Product hierarchy no. *				Part no.	SBU	Type / Description	Customer part no.
SBU	PG	PUG	Type				
02	005	116	0000001167	See list below	Power Entry modules 10A	DC21

Product Change Notification					PCN DC21		
owner	creation date	release date	released by	change order no	rev	page	D10-013-559
hotzar	2017-02-01	2017-02-16	buerglal	2012095	A	1 of 2

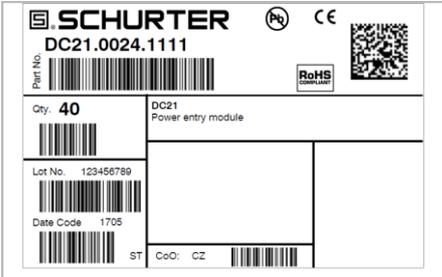
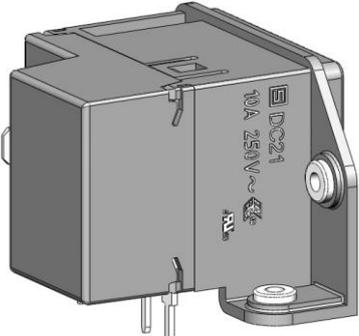
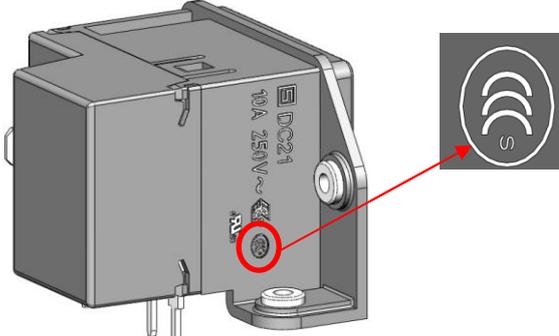
- Change of markings
- Modified packing label

Old label	New label

Old approval marks on product	New approval marks on product

- Product has new CCC approval.
